Re: RZ 82-C-016  
Tax Map 24-4(1) 3  
Approx. 82 acres

SUBJECT: Environmental Site Analysis: RZ 82-C-016

SUBJECT: Development Plan, Rezoning Application RZ-82-C-016

SUBJECT: Rezoning Application 82-C-016, TM 24-4((1))3

SOIL TYPE MAP OF AN 80.0 ACRE PARCEL, PROPOSED FOR REZONING FROM R-1 TO I-5 (IND GENERAL USE) LOCATED ADJACENT TO THE SOUTH OF BRASHEEN RUN, ADJACENT TO AND AVE. OF MC LEAREN ROAD, SECTION 24 AND 25, OF CO. 1, PUBLIC ROAD. REZONING REQUESTED BY: EDYSON M. SMITH, TRACT NO. 2000 NUMBER: 85-0-016.

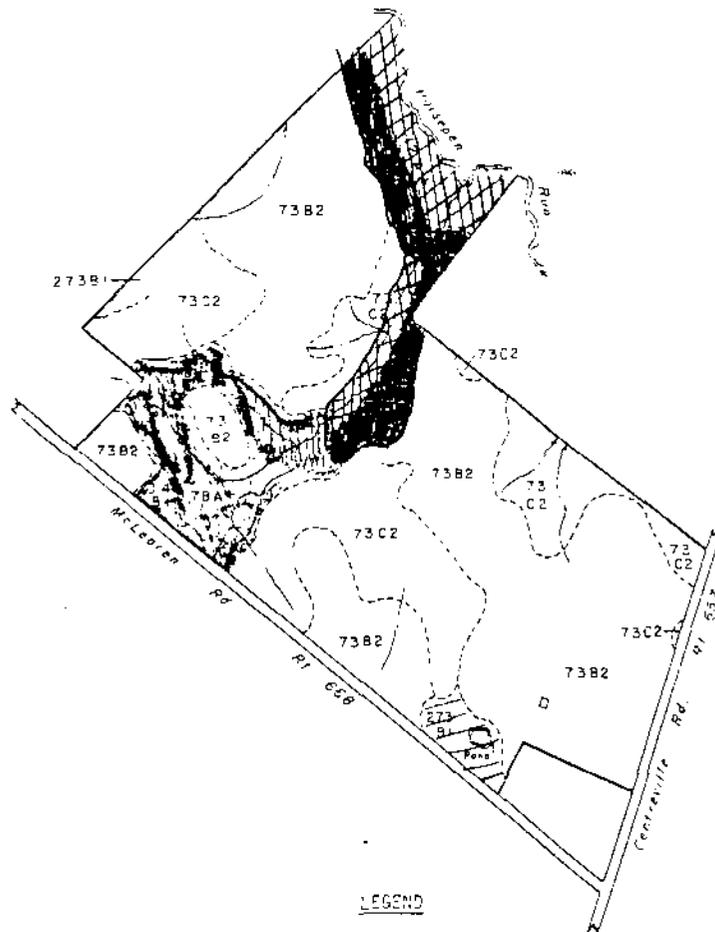
1. No grading or clearing should occur within the EQC as delineated on the soils map in Attachment 2.
2. No grading or clearing should occur within 50 feet of either side of the natural swales which drain the site.
3. Sedimentation and erosion controls should be adhered to strictly.
4. Stormwater management should be provided as directed by D.E.M. Stormwater management is important to this sensitive upstream location.
5. A spill containment program as discussed under Geology should be provided to avoid contamination of surface water.

1. No clearing, grading, or construction should occur within the EQC as defined by the Rowland soil (12A+) and the Penn shaley silt loam (77D2). See Attachment 2 for map. These should be kept in natural vegetative cover.
2. If basements are constructed, they should be engineered to ensure dryness.

FAIRFAX COUNTY  
 D.C.P.-PLAN IMPLEMENTATION BRANCH  
 5TH FLOOR - MASSEY BUILDING  
 DATE RECEIVED 5-25-82 FOR I-5  
 CASE NO. 127-82-C-016 SUBMISSION NO. 1

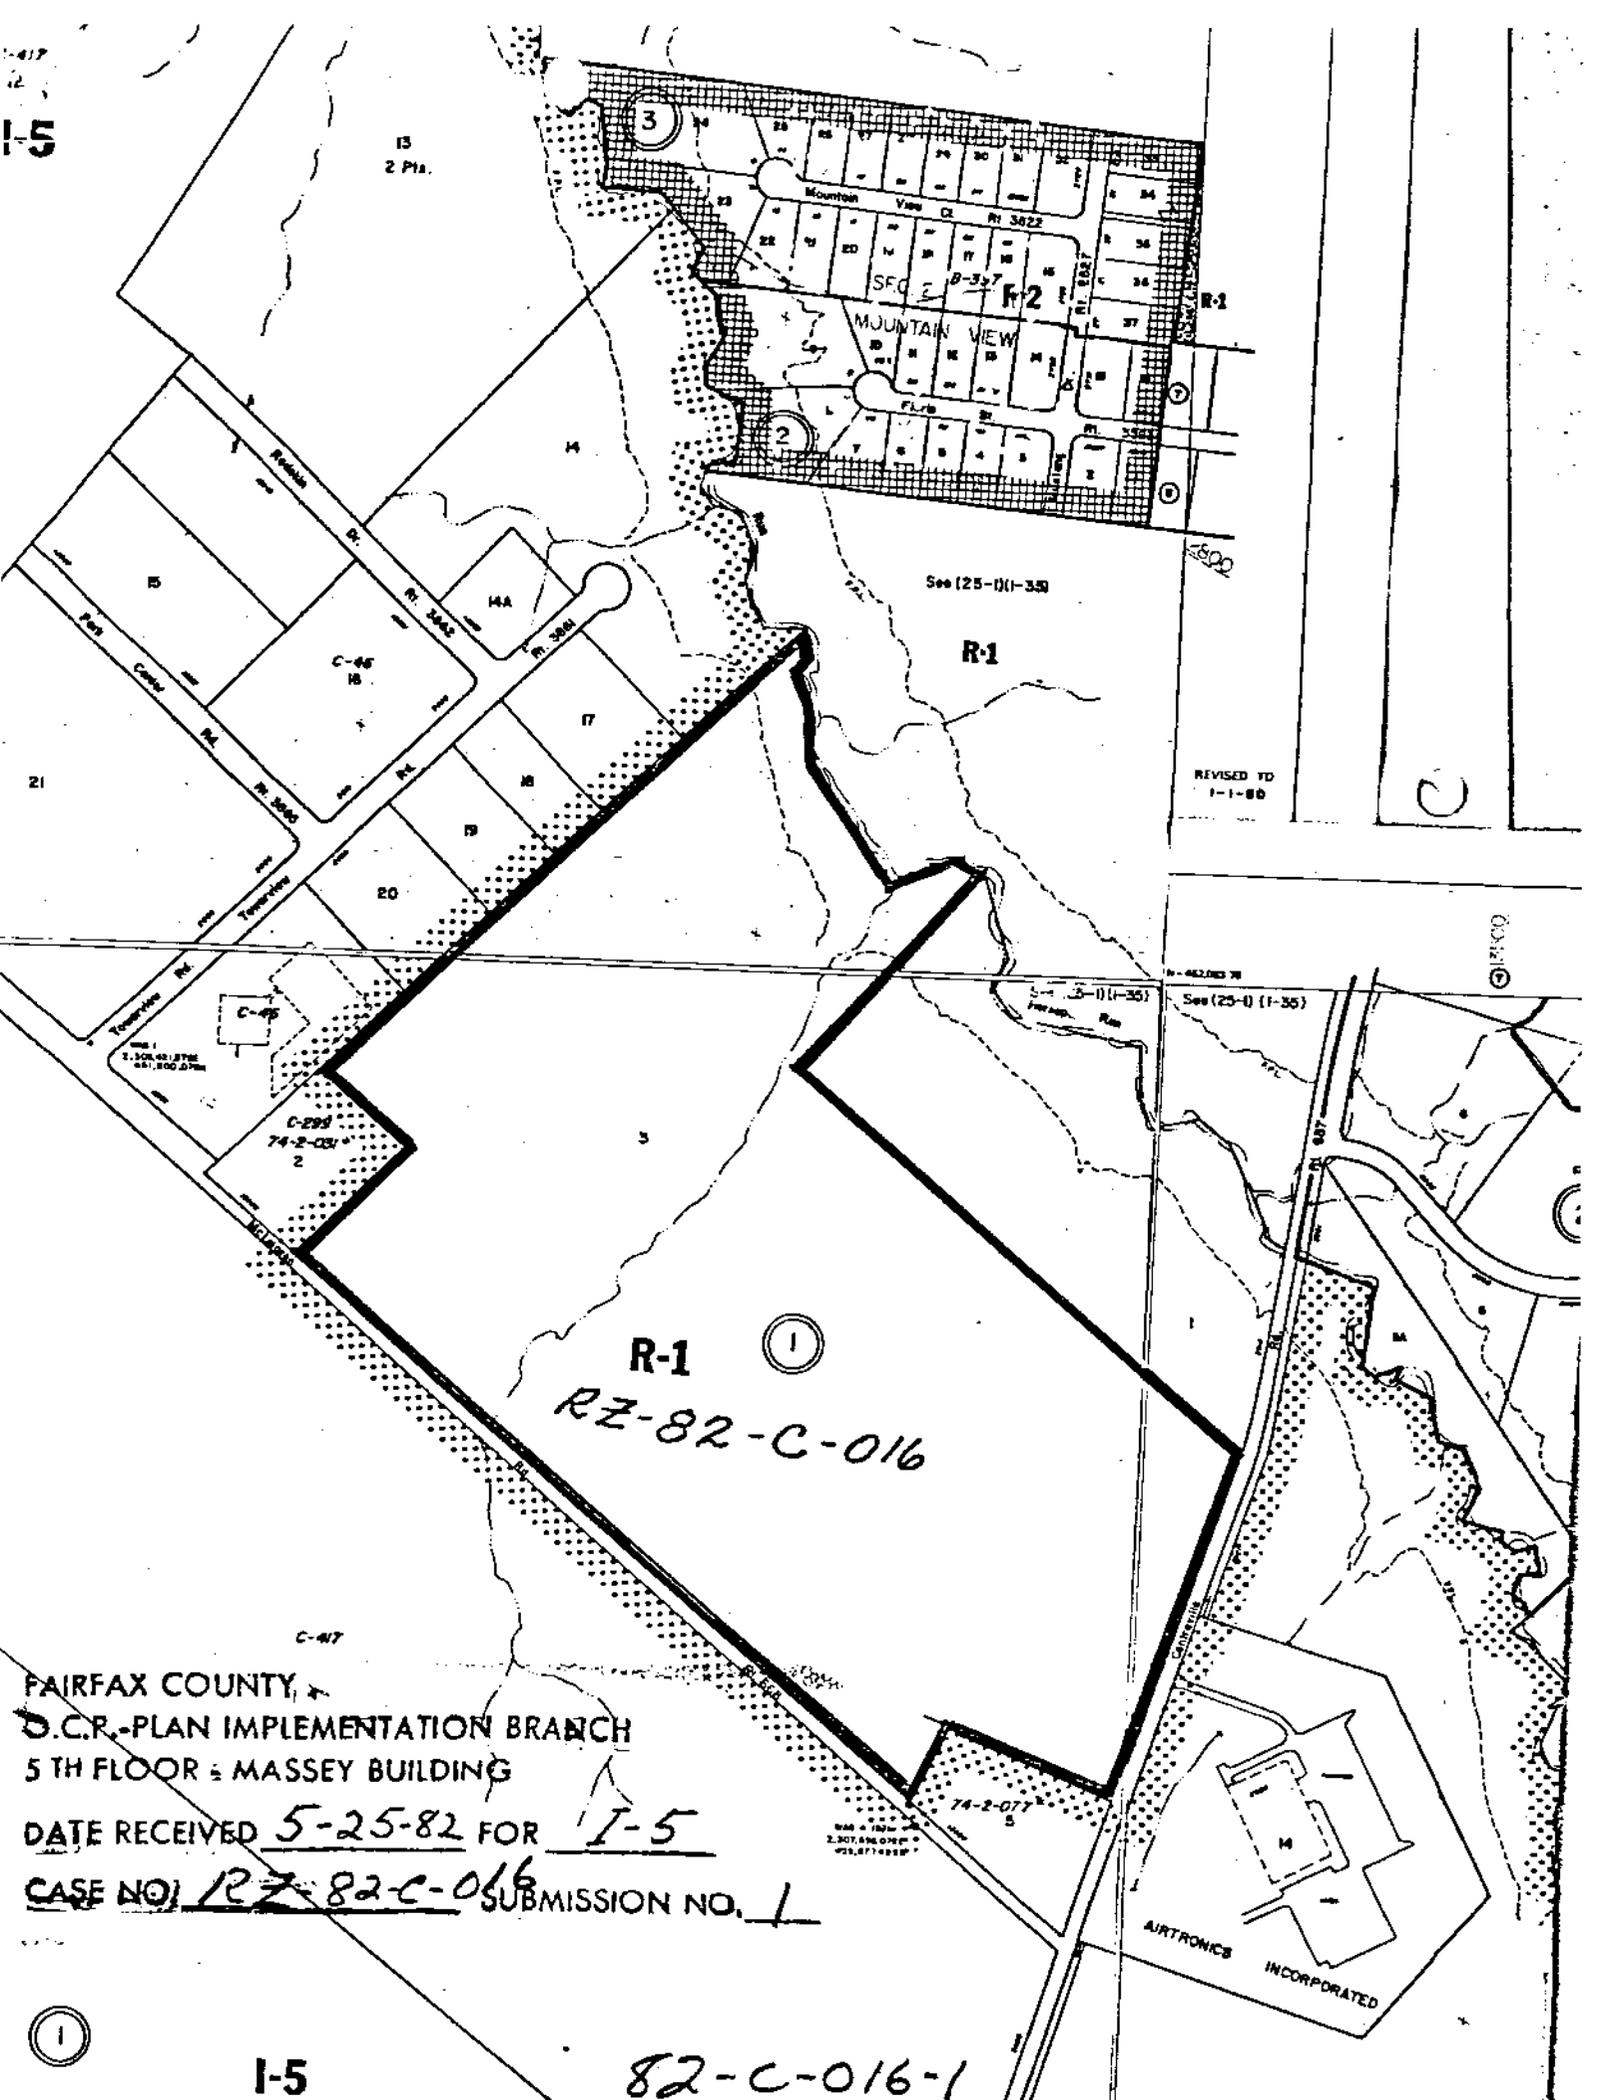
- 1) McLearn Road, Route 688, is to be dedicated to 45' from centerline. Curb location is to be at 35' from centerline.
- 2) Centreville Road, Route 657, is to be dedicated to 45' from centerline. Curb location is to be 35' from centerline.
- 3) Transition yards shall apply.
